Howard County  
Health Department

RECEIPT DATE: 5-16-14 **ONSITE SEWAGE DISPOSAL SYSTEM**

PROPERTY ADDRESS: 2684 Daisy Road

**From:** Williams, Jeffrey  
**Sent:** Wednesday, April 16, 2014 2:45 PM  
**To:** 'mel@vanmar.com'  
**Cc:** Rob Scranton; dkv@vanmar.com; tmv@vanmar.com  
**Subject:** RE: 2684 Daisy BAT plan

2684 Daisy Road

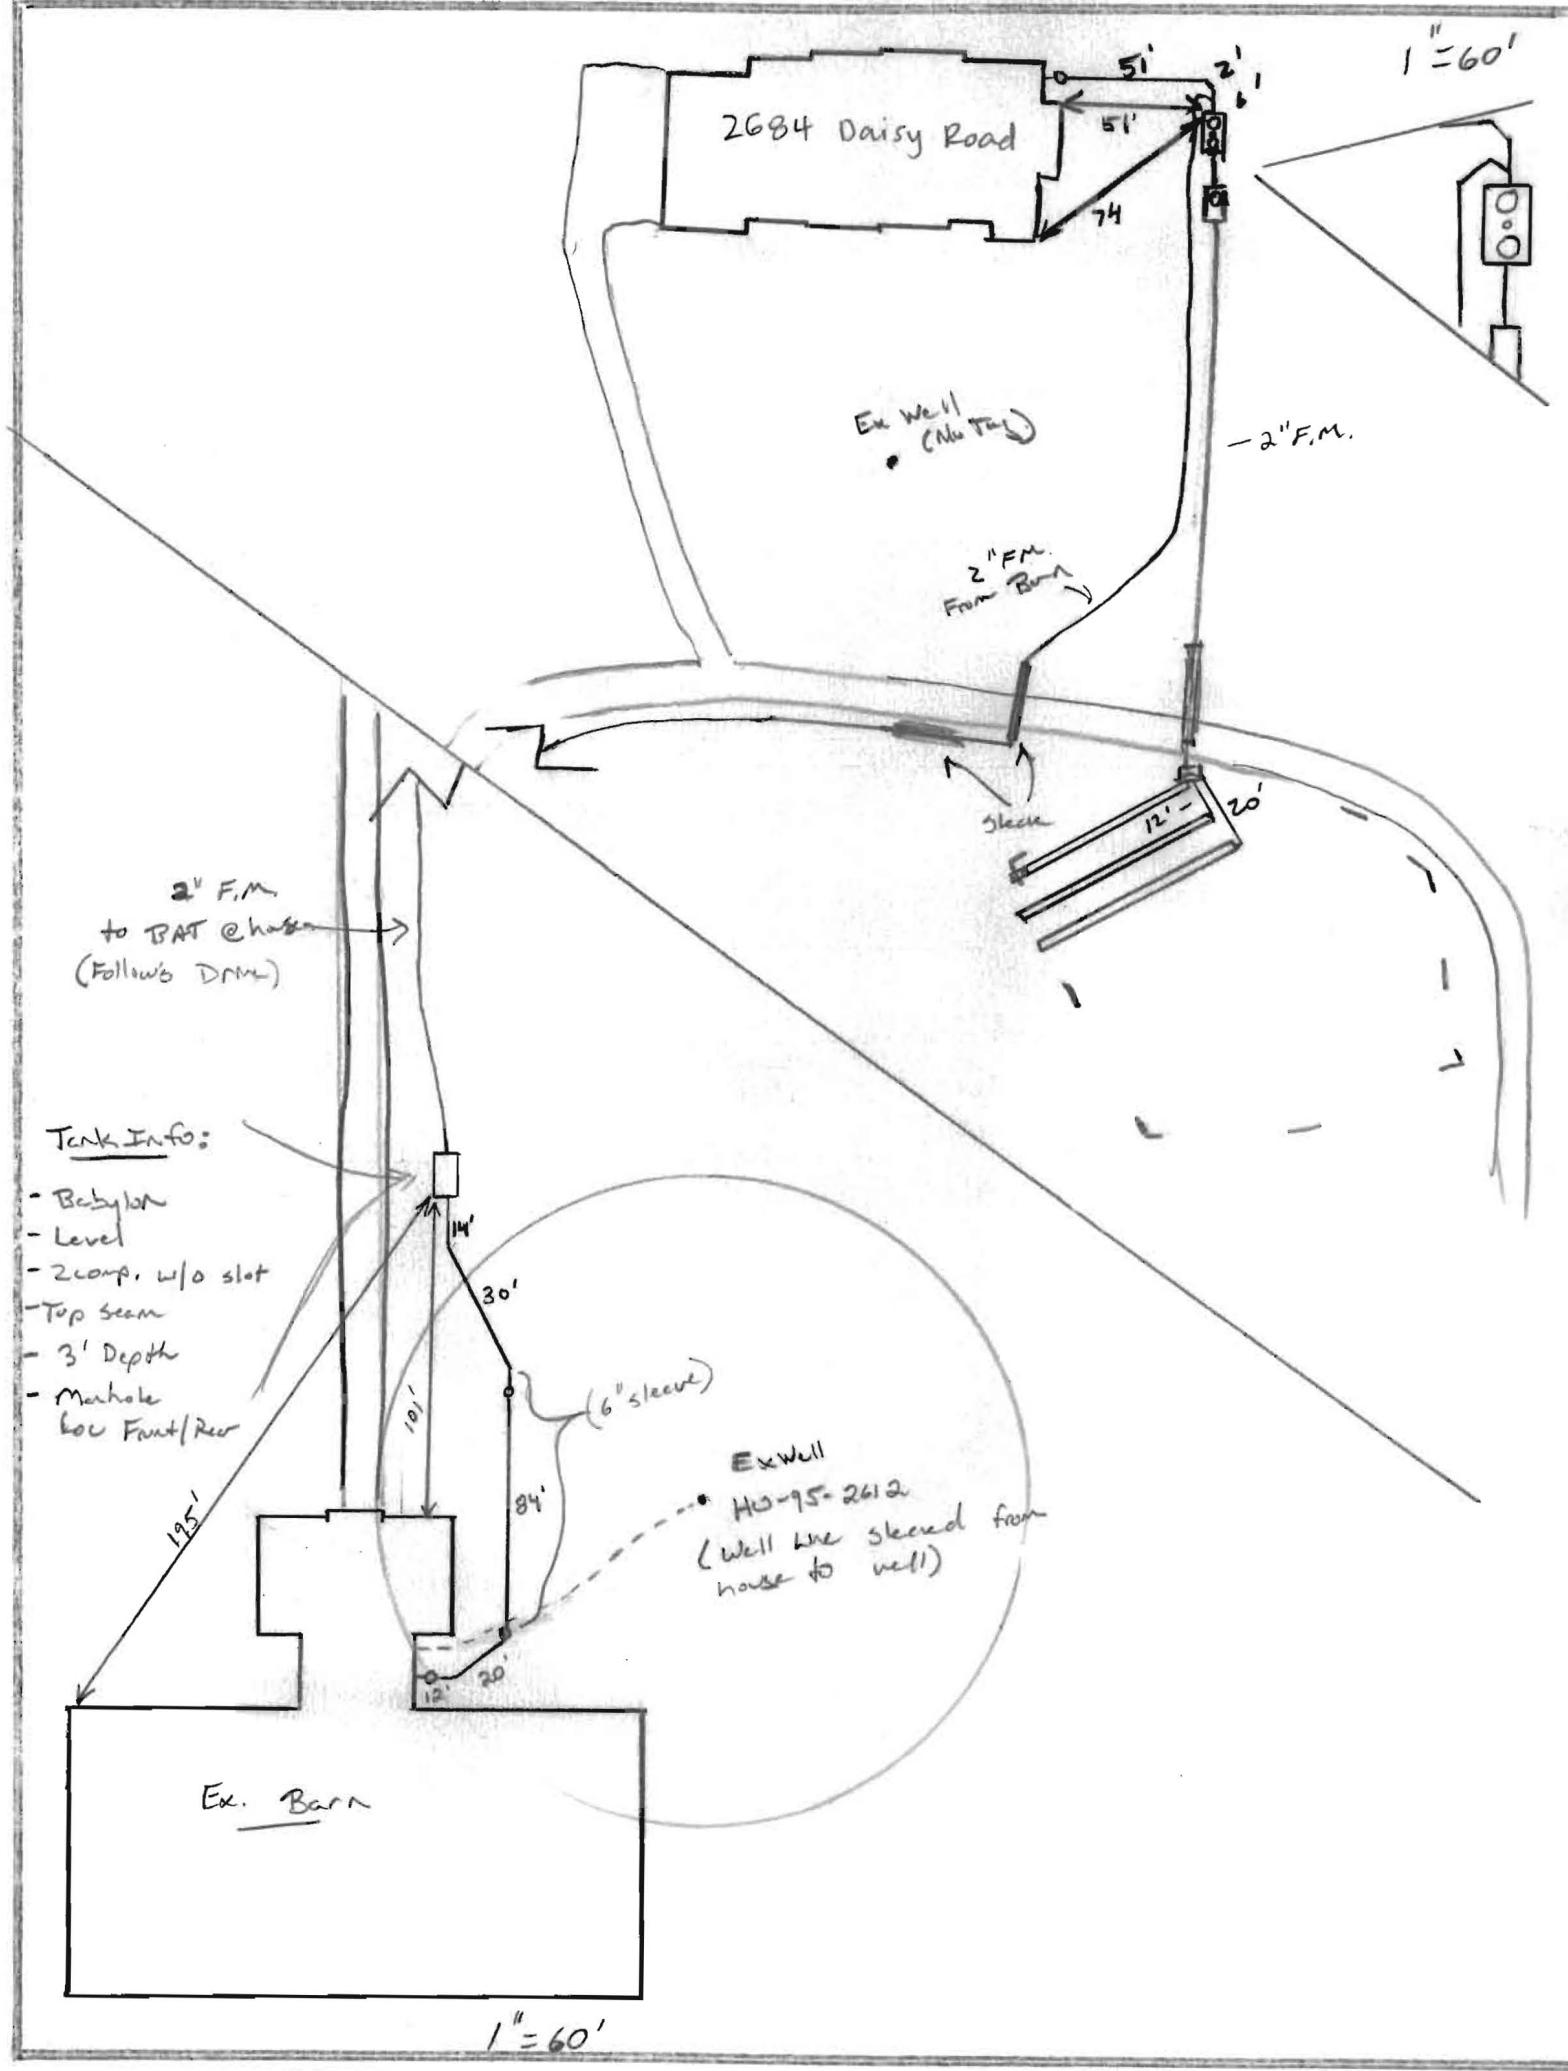
7/30/15 Pump + alarm with WTC. Alarm at barn pump tank works, pump successfully pumps to BAT tank at house. Pump tank at house pumps to D-box. Alarm at house pump tank not working properly - automatically on when reset and alarm float is in down position. Ecopod alarm also triggers pump alarm even when pump alarm circuit is off. Electrician will need to fix wiring. (SC) 8/14/15 Wiring fixed - alarm now triggered by float in pump tank. Need BAT startup certification. (SC)

6/19/14 Contractor had trenches complete. Looks OK. Stated @ SHC. BAT unit and PT. Staked per revised BAT site plan. Increase size of Dbox to larger (7 hole) box instead of smaller 3 hole box. This will eliminate blowout of pump down. OK to continue. 6/23/14 SHC installed. Tanks set. All F.M. installed. Shavings seen @ crossing. Told contractor to send pics, could not see crossing below ex. water lines. Need BAT + Pump test of all systems prior to release. ROAD NAME (KWD)

5/21/14 on-site w/ contractors and builder. Everything stated per plan. OK to <sup>set</sup> pump tank for barn per plan. May need to move tank further down hill to make fall. Should be OK. Line from barn needs to be cleared. Need to be 12" below and under line crossing. Set BAT unit per stake out. Elevations shot in field. Run's stake to stake per plan. Install 3x6.5" as perched out in field. Trenches spec'd as show on permit call for map. (KWD)

5/28/14 Tank set for Barn. F.M. run up to Dbox. Need 6" baffle on west side of tank. 12" vertical separation made @ cross of well line and 4" sewer @ barn. Informed project manager on-site should have engineer show all proposed well lines on revised BAT site plan. OK to cover work completed so far. BAT location to change location. (KWD) 5/6/14 Pump set in tank @ barn. Inlet baffle changed to 6". (KWD)

PLOT PLAN  
LANDS CONVEYED TO  
KATHY & KEVIN VASQUEZ  
AS RECORDED IN LIBER 15104 AT FOLIO 299

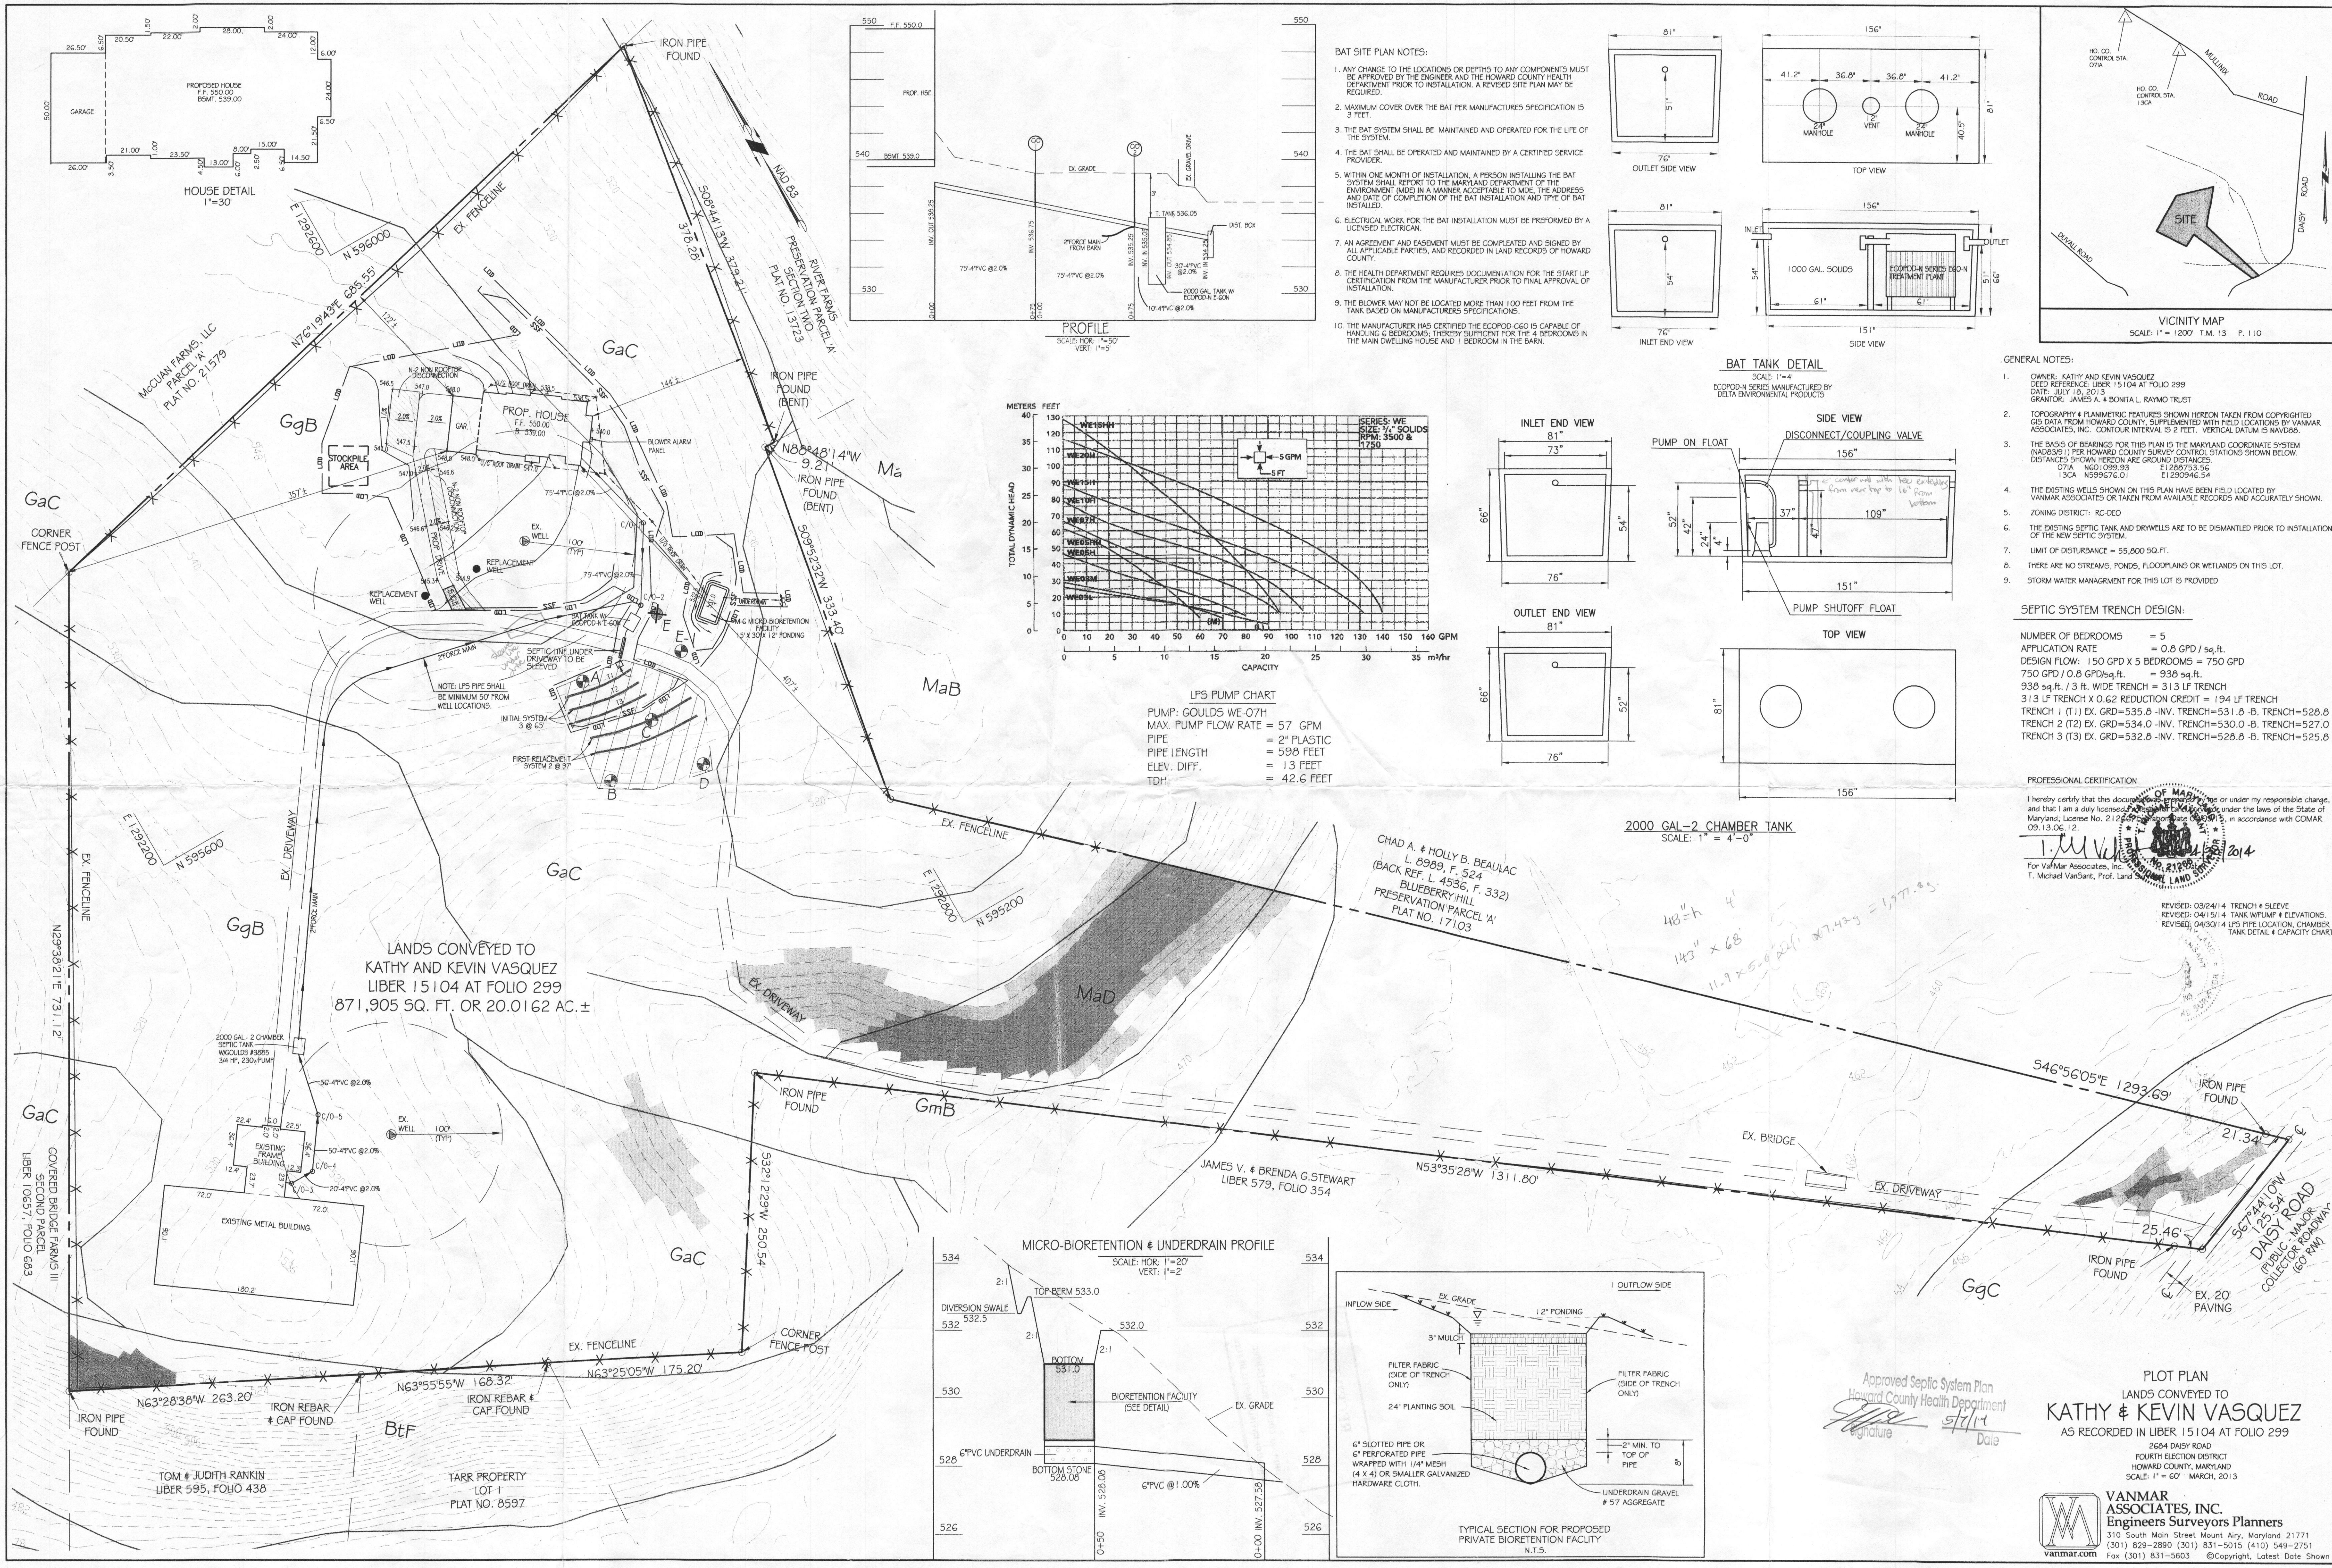
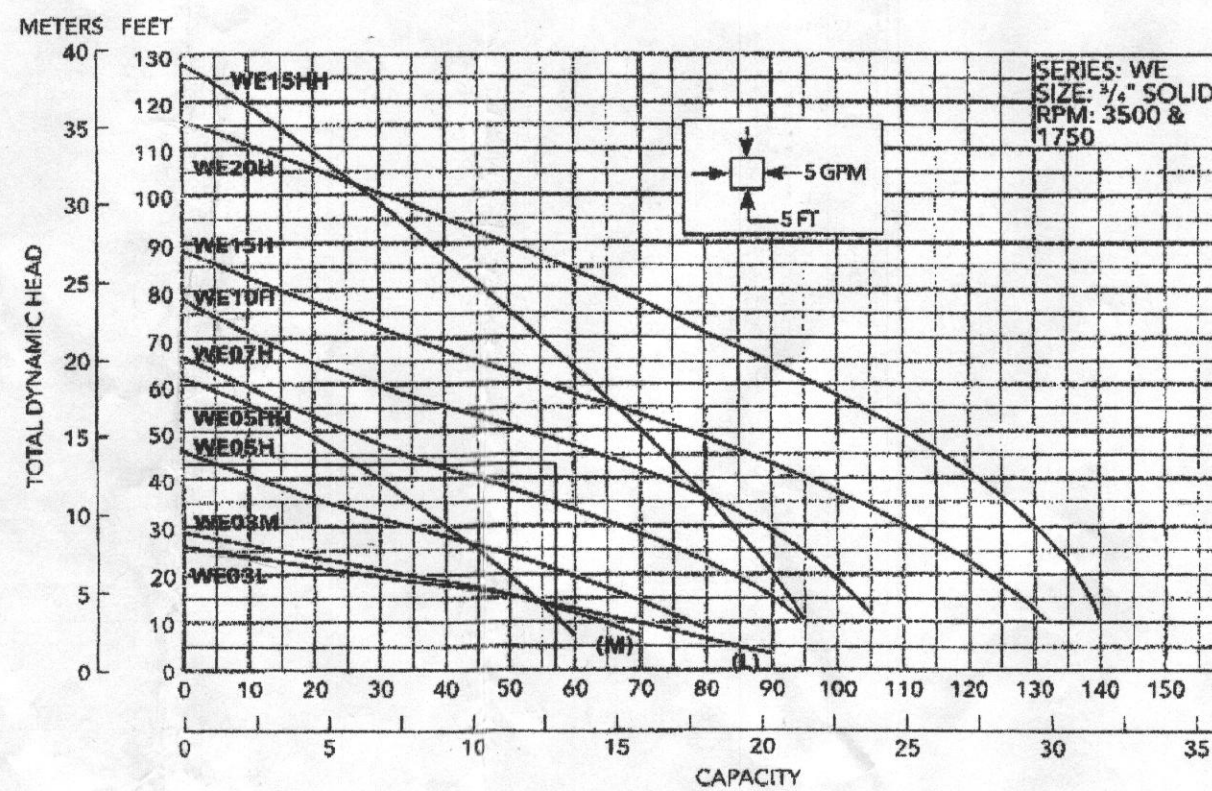
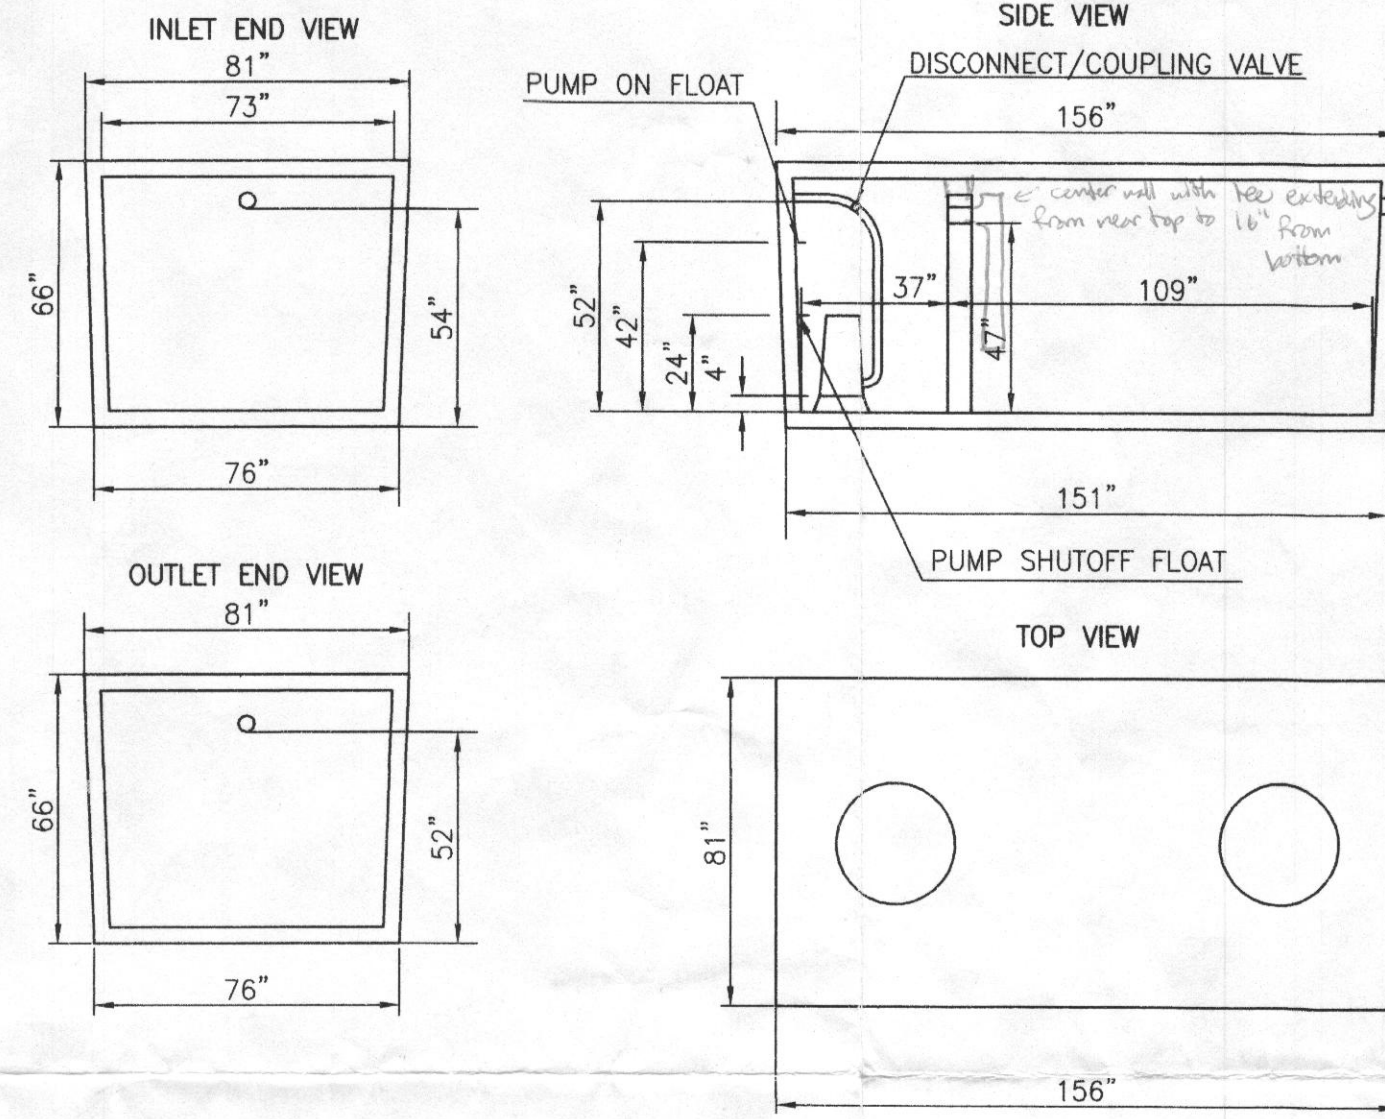
The diagram looks good. We will also need the plan to show the pump curve and related info: the design head with calculations, the dose volume, flow rate, pump model chosen. We will also need to see the pump tank cross section with detail of pump float elevations for dosing and emergency storage. Also, since you are proposing a two compartment tank with pump in the second chamber, the middle wall may not have a center slot, it must have a center pipe opening near the top of the tank with tees that extend from near the top of the tank to 16" below the invert. This detail must be shown on the tank cross section. Thanks.

The two comp tank can't have just a slot at the top, it needs a solid center wall with a hole near the top and piping installed with tees extending from near the top of the tank down to 16" from the bottom. Specify that the pump will sit in the second compartment and show the float elevations and show the dose as well as the volume of emergency storage.

You'll need to show the calculations for design head corresponding with the pump curve and pump model shown. This will include the elevation difference as well as friction loss in the force main. Thanks.

- We need to see the details of the barn connection to the system on the plan
- The plan should indicate the ground elevation, trench invert elevation, and trench bottom elevation for each trench.

Something else regarding the BAT plan: please make sure to show the force main from the barn to come no closer than 50' to the house well locations. I think the most sensible path is to go under them and cross the driveway near the BAT unit and run the line up next to the BAT unit to tie in just above. Thanks  
Jeff

Also, can you verify with the ecopod people that they are ok with the model chosen to serve the flows from the 5 bedroom house as well as the laundry/bathroom in the barn and put a note on the plan stating that the manufacturer has declared the model chosen to be appropriate for the property. Thanks.

10. THE MANUFACTURER HAS CERTIFIED THE ECOPOD-650 IS CAPABLE OF HANDLING 6 BEDROOMS; THEREBY SUFFICIENT FOR THE 4 BEDROOMS IN THE MAIN DWELLING HOUSE AND 1 BEDROOM IN THE BARN.

LPS PUMP CHART  
PUMP: GOULDS WE-07H  
MAX. PUMP FLOW RATE = 57 GPM  
PIPE = 2" PLASTIC  
PIPE LENGTH = 598 FEET  
ELEV. DIFF. = 13 FEET  
TDH = 42.6 FEET
